ADDENDUM No. 2

Construction of Permit Office at SSR International Airport for the
Department of Civil Aviation

CAV/QUO: No.11 of 2025-26

TARMAC DETAILS

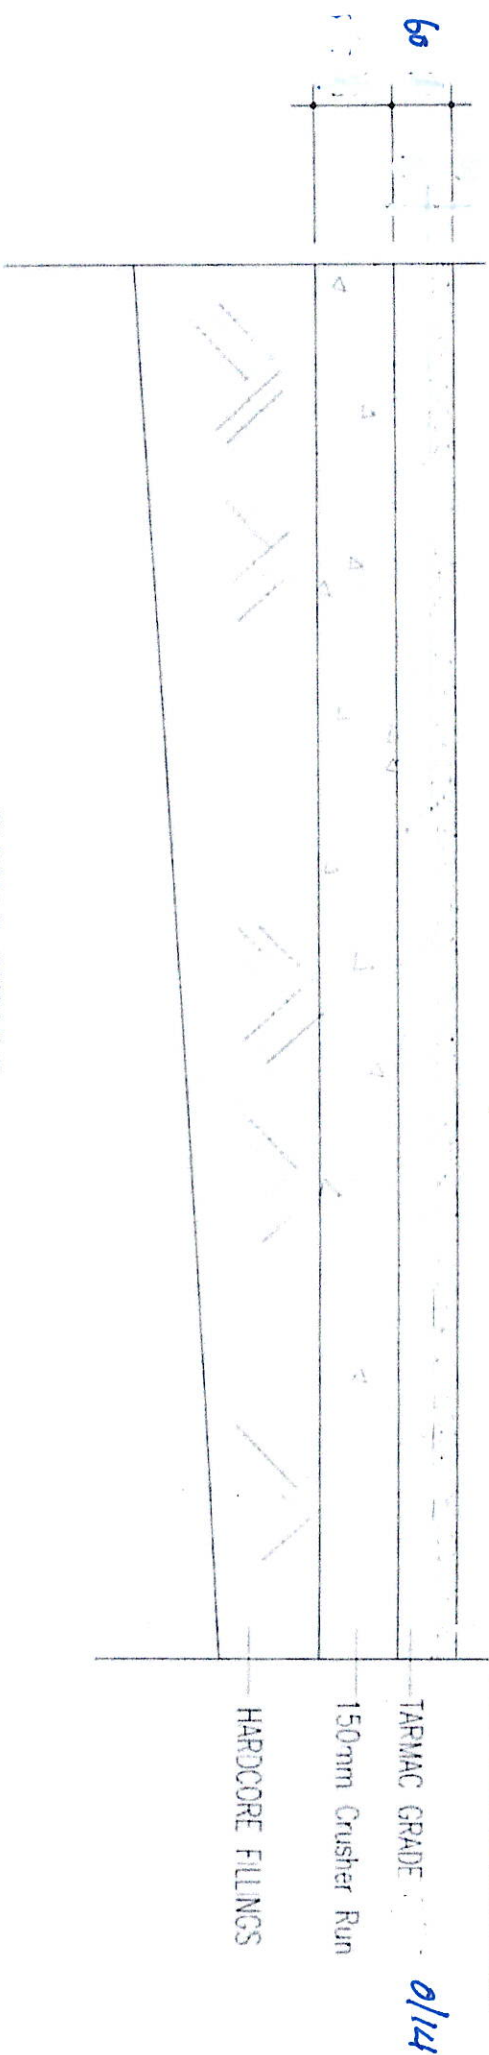
Bidding Doc Vol II, Bill No 7- Item 18, describes for "**60mm thick Premix Asphalt of grade 0/14**" whereas Structural Engineers Drawing shows "*30mm thick with two different grades*"-PLEASE CLARIFY

TARMAC DETAILS : NOTE THAT ALL MATERIALS OF LAYERS TO BE COMPACTED :-

- (1) Top Soil (Hardcore fillings) to be Compacted
- (3) 150mm Top Layer of Crusher Run to be Compacted
- (4) ~~20~~mm Layer Tarmac Grade 5 - to be Compacted

Our consultant has confirmed that the TARMAc thickness shall be **60mm** as detailed in the *BILL OF QUANTITIES* and Base-Course & Wearing-Course to be merged into in a single layer of 0/14 Premix Asphalt as depicted in the attached Annex.
